IEEE 802.16 Broadband Wireless Access Working	Group <http: 16="" ieee802.org=""></http:>
	Harmonized proposal to replace traffic models in	IEEE 802.16j-06/013
Date Submitted	2006-09-27	
Date Submitted Source(s)	2006-09-27Wendy C Wong wendy.c.wong@intel.comRoshni SrinivasanHannah Hyunjeong LeeKerstin JohnssonJerry SydirSassan AhmadiBelal HamzehShailender TimiriIntel Corporation2200 Mission College Blvd.,Santa Clara, CA 95054, USA.I-Kang FuIKFu@itri.org.twNational Chiao Tung University /Industrial Technology Research Institute1001 Ta Hsueh Road,Hsinchu , Taiwan 300, ROC.Peter Wang peter.wang@nokia.comNokia US6000 Connection DrIrving, TX 75039, USA.David Chen david.t.chen@motorola.comHua XuRoger PetersonMotorola Inc1441 W. Shure Drive,	Mike Hart, Sunil Vadgama Mike.Hart@uk.fujitsu.com Fujitsu Laboratories of Europe Ltd. Hayes Park Central Hayes End, Middx., UB4 8FE, UK. Peng-Yong Kong, Haiguang Wang kongpy@i2r.a-star.edu.sg Institute for Infocomm Research 21 Heng Mui Keng Terrace Singapore 119613 Dharma Basgeet@toshiba-trel.com Toshiba Research Europe Limited 32 Queen Square Bristol BS1 4 ND Jun Bae Ahn jbahn@st.co.kr SOLiD Technologies 10 th Fl., IT Venture Tower East Wing, 78 Garak-

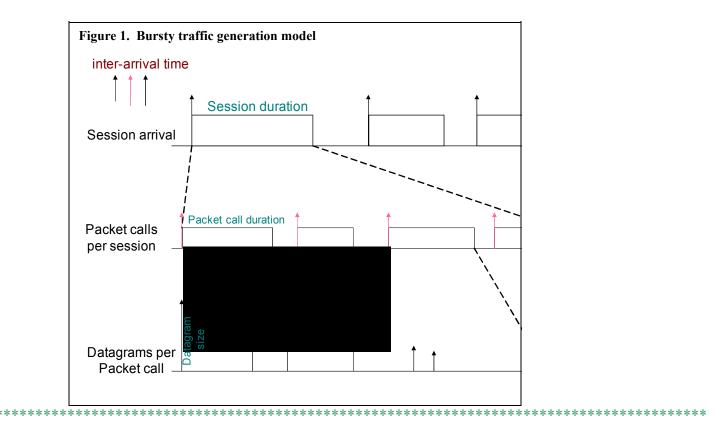
[Editor's note: Insert the following text and Figure 1. The first paragraph summarizes the Appendix C.3.3]

The FTP and HTTP traffic models listed in Table 1 can be generated using the bursty traffic generation model described in Figure 1. For each traffic source, the following characteristics are modeled:
